Access Compliance Report

Public Rights-of-Way

Intersection ID: 11054	Main Street: DOWNS_AV	Cross Street: NEWELL_AV	Location: S
ADA ID: 6DDAA3CDC588	Ramp Type: Perp	Initial Pass/Fail: Fail	Overall Compliance: No
			Severity Score: 21.25

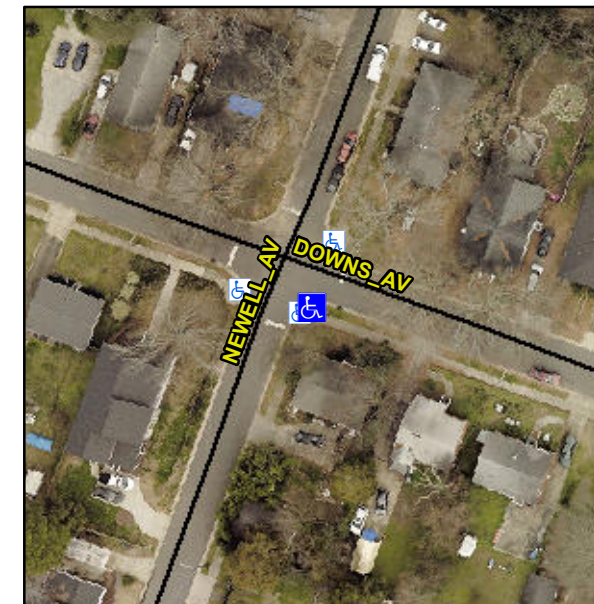
Not Found, R304.5.1, R304.5.3

Compliance	Description	Data	Compliance	Description	Data
N/A	Ramp Length (in)	69.0	Yes	Ramp Slope (%)	5.7
No	Ramp Width (in)	47.5	No	Ramp XSlope (%)	5.8
N/A	Flare Type LT	N/A	N/A	Flare Type RT	N/A
N/A	Flare Slope LT (%)	N/A	N/A	Flare Slope RT (%)	N/A
N/A	Flare Traversable LT?	N/A	N/A	Flare Traversable RT?	N/A
N/A	Landing Length (in)	N/A	N/A	DWS Provided?	N/A
N/A	Landing Width (in)	N/A	N/A	DWS Contrast?	N/A
N/A	Landing Slope (%)	N/A	N/A	DWS Length (in)	N/A
N/A	Landing X Slope (%)	N/A	N/A	DWS Full Width?	N/A
N/A	Landing Curb? (Y/N)	N/A	N/A	DWS Offset (in)	N/A
N/A	Shared Landing?	N/A			
N/A	Gutter Ponding?	N/A	N/A	Gutter Slope (%)	N/A
N/A	Gutter Lip Ht (in)	N/A	N/A	Gutter X Slope (%)	N/A
N/A	Painted X Walk1?	No	N/A	Painted X Walk2?	N/A
	X Walk 1 Direction	To NE		X Walk 2 Direction	N/A
N/A	X Walk 1 Width (in)	N/A	N/A	X Walk 2 Width (in)	N/A
	X Walk 1 Slope (%)	2.7		X Walk 2 Slope (%)	N/A
	X Walk 1 X Slope (%)	3.4		X Walk 2 X Slope (%)	N/A

Remove & Replace Entire Ramp.
